Your ref:  
Our ref: LTR-NRC-02-60

Subject: Response to RAI on the "Topical Report on Modular Accident Analysis Program Version 5 (MAAP5) Pressurized Water Reactor (PWR) Large Dry Containment Model," WCAP-15844

## 2.0 MAAP5 Topical Report

Figure 3: Comparison of the calculated and measured heat transfer coefficients above the operating deck when the steam is discharged into node 2.

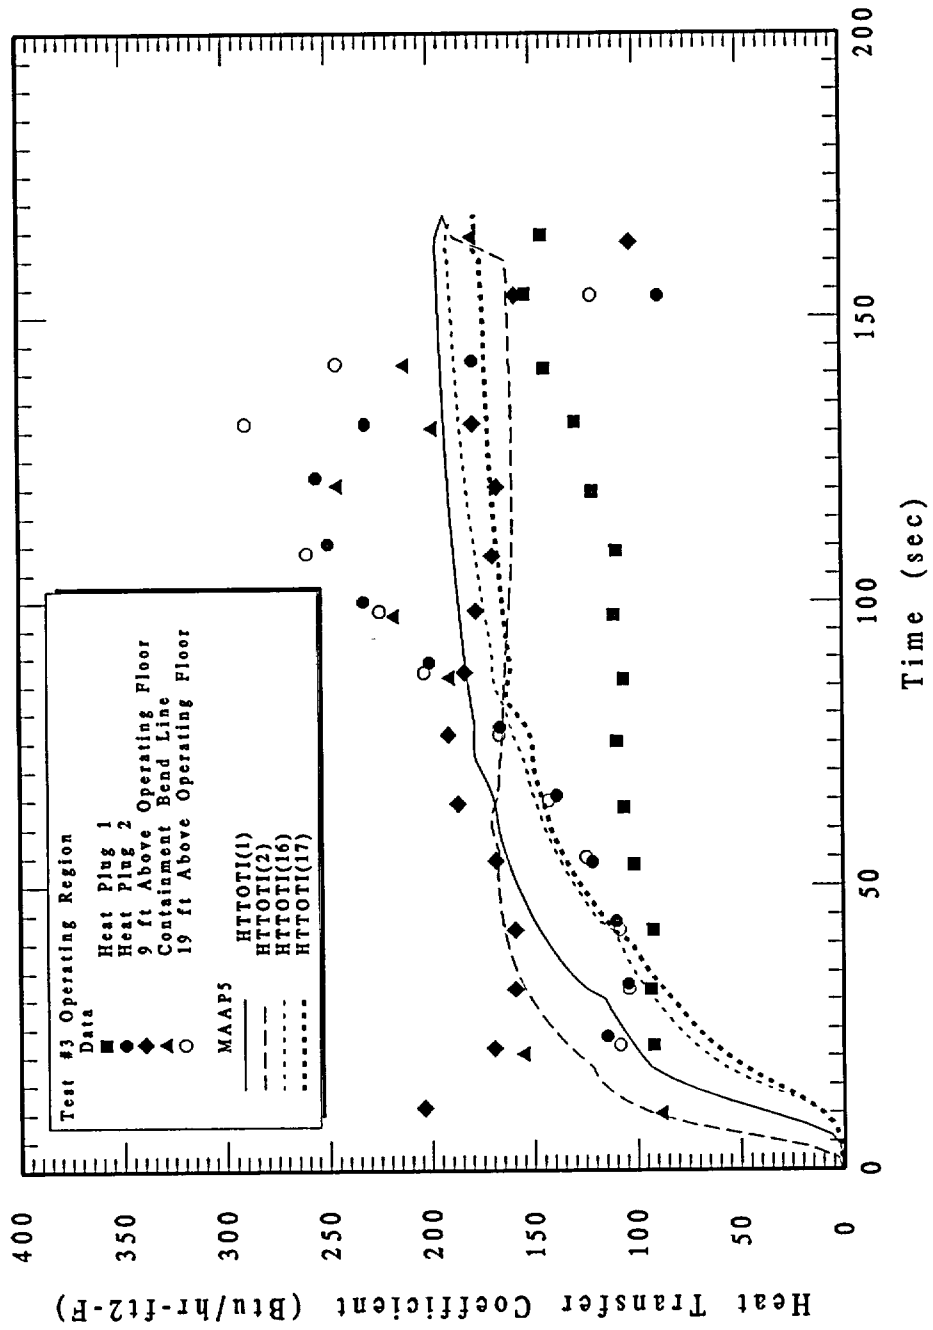
**Item 2.2.10. Provide a comparison of CVTR heat plug #2 heat transfer coefficients calculated for the MAAP uncertainty parameters.**

The Heat Transfer Coefficients (HTCs) deduced through the heat plug measurements, as well as those HTCs deduced from the measured temperatures on the inside and outside of the containment liner, are compared (Figure 3) with the MAAP5 calculated values when the mass and energy release is discharged only into node #2. Figure 4 compares the same quantities when the mass and energy release is simultaneously discharged into nodes 2 and 6. In these figures heat transfer coefficient  $HTTOT(1)$  is for the containment wall heat sink in node 1,  $HTTOTI(2)$  is the calculated heat transfer coefficient to the wall in node 2,  $HTTOTI(16)$  is the heat transfer coefficient to the containment wall in node 5 and  $HTTOTI(17)$  is the heat transfer coefficient to the containment wall in node 6. The calculated and measured heat transfer coefficients are in agreement.
